## PLANNING COMMISSION AGENDA REPORT

**SUBJECT:** REVIEW OF A NEW MIXED-USE PROJECT THAT CONTAINS APPROXIMATELY 23,164 SQUARE FEET OF COMMERCIAL SPACE AND A ONE BEDROOM RESIDENTIAL UNIT, WITH ASSOCIATED SITE IMPROVEMENTS, A SIGN PROGRAM, AND A REQUEST TO REMOVE TWO TREES AND REPLANT 25 TREES

**PROJECT ADDRESS:** 10 Higuera Street

**FILE NUMBER:** ARCH-0358-2023

**Figure 5: Revised north elevation with additional window fenestration and wood detailing.**

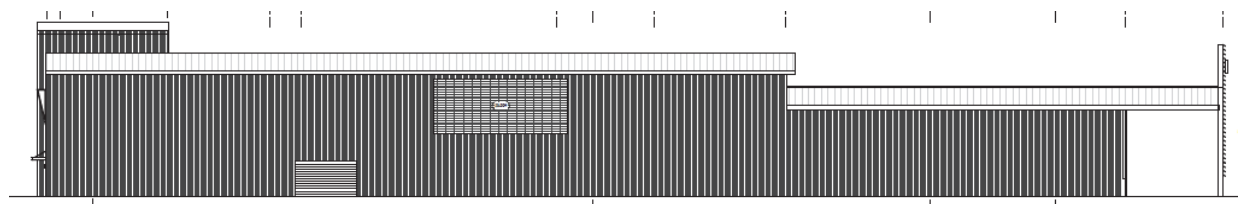
1. *Provide a change in color, materials, and/or window fenestration to the north elevation to provide architectural interest.*

Per direction from the ARC, the applicant has revised the north elevation to include more architectural interest by adding window fenestration and wrapping the wood accent feature from the west elevation around to the north elevation. Attachment B, Project Plans, includes the revised north elevation as part of the plans. The Planning Commission should discuss if the proposed revisions provide sufficient articulation and architectural features to break up the large wall expanse on the north elevation.
